# PLANNING AND ZONING COMMISSION

STAFF REPORT

May 16, 2013

# Rezoning case no. RZ12-08: WBW Land Investments, LP

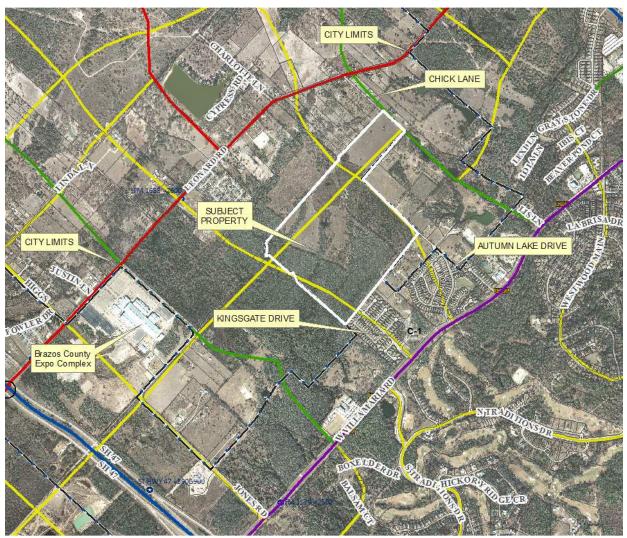
Staff also has no objections to reducing the minimum front building setbacks of the 71 lots proposed in Phases 6 and 7 (potential duplex lots) to 15 feet. This will allow for a planned flexibility in the design and build out of these two subdivision phases, and allow potential variety of housing types as part of this development, while still maintaining a minimum degree of open space. **Staff recommends, however, that the following note be added to the development plan in consideration of Land and Site Development Ordinance Section 62-169 (Duplex Requirements): "Lots to be developed with duplexes in Phases 6 and 7 of this development shall have a minimum lot width of 70 feet and minimum area of 7,000 square feet." Adding this note will help avoid confusion about minimum lot requirements when duplexes are proposed to be built here in the future.**

**Staff is <u>not</u>** inclined to recommend that the side building setbacks in this proposed development be reduced to 5 feet. During the SDRC review process, the City's Fire Marshal repeatedly stated his concerns about the proposed reduction of minimum building setbacks. Reducing side building setbacks increases the opportunity to have an extension of fire from one house to the next. It is important to note that the International Residential Code which the City of Bryan adopted allows for a reduction of side building setbacks to 5 feet so long as a structure has a sprinkler system, yet Texas State law prevents the City from requiring residential sprinkler systems. For safety reasons, the Fire Marshal believes that minimum 7.5-foot side building setbacks required by ordinance should not be negotiated.

- 1. Add note: "Lots to be developed with duplexes in Phases 6 and 7 of this development shall have a minimum lot width of 70 feet and minimum area of 7,000 square feet."
- 2. Amend note concerning lots fronting Kingsgate Drive and the major collector: "Lots fronting Kingsgate Drive and the major collector shall have adequate maneuvering space so vehicles will not be allowed to back directly into these streets."
- 3. Depict the extensions of Autumn Lake and Kingsgate Drives north of the major collector using the same grey "collector street" fill color used for depicting the remainder of these streets.
